CITY OF NORTH OAKS

Regular Planning Commission Meeting

7a. Public Hearing - Consider Conditional Use Permit for building height in excess of 35 feet for property located at 8 Sherwood Trail. Consider driveway setback variance.

PLANNING REPORT

SHEET NUMBER
A4

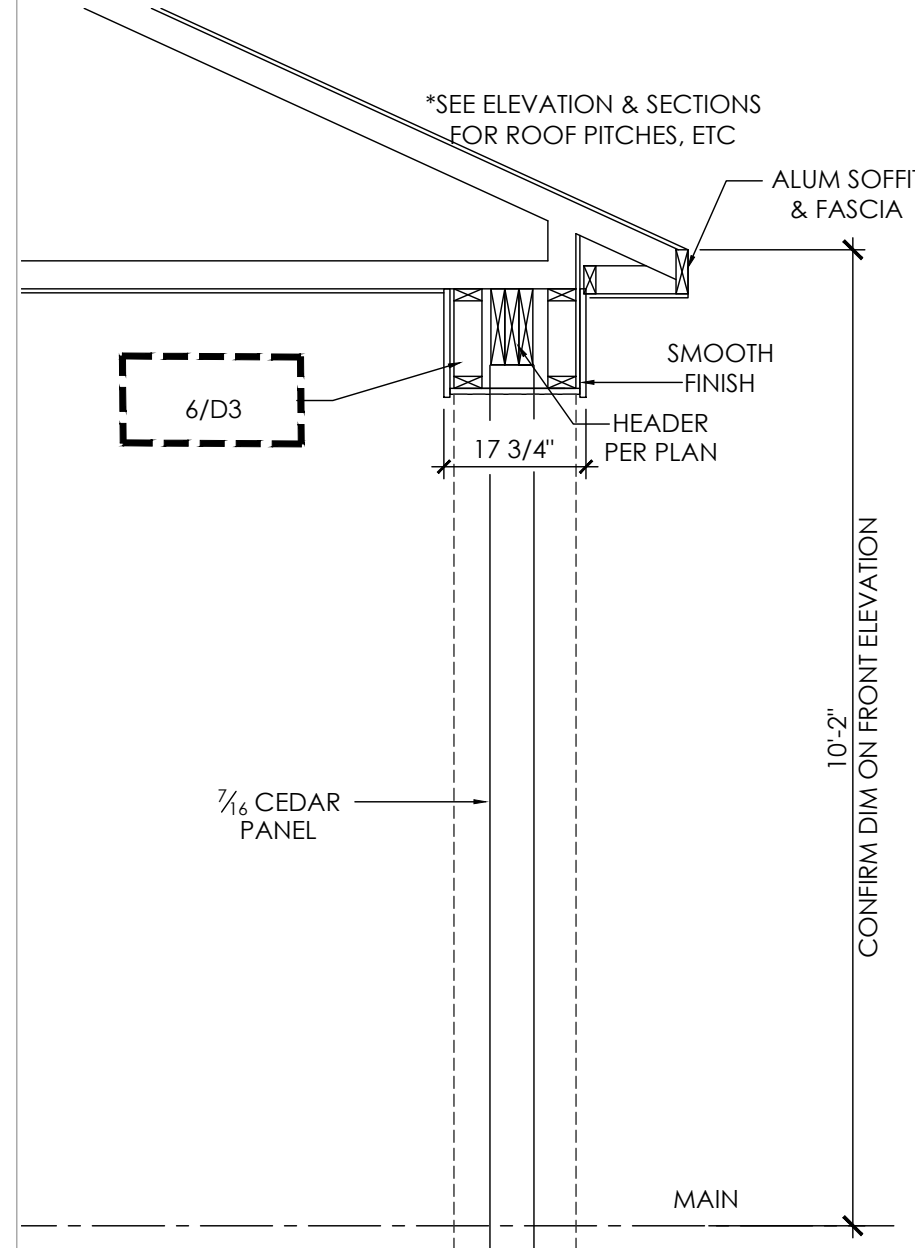
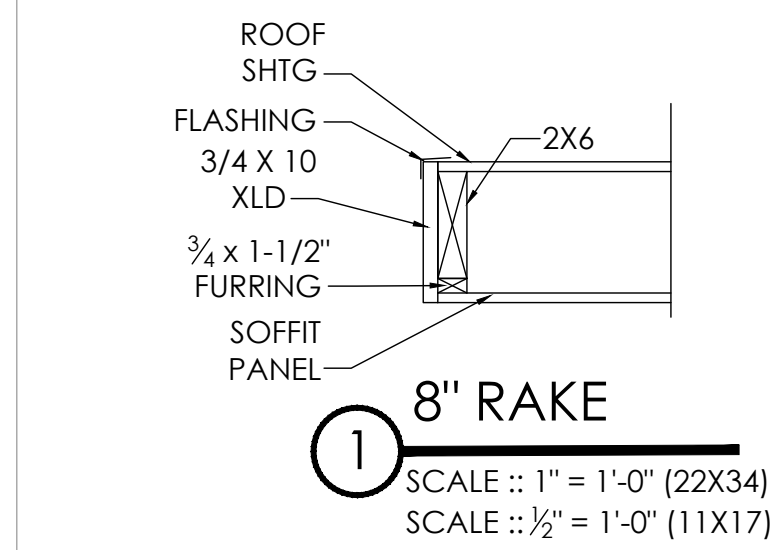
The applicant is requesting a CUP to allow the southern (rear) elevation of the proposed home to exceed 35 feet in height. Elevations provided by the applicant show the proposed home to be 44.2 feet in height along the side and rear facades. The front facade of the home is 34.9 feet in height. Building height is defined as the vertical distance from grade to the top ridge of the highest roof surface in Section 151.005 of the Zoning Code.

The proposed front elevation does not exceed 35 feet at any point.
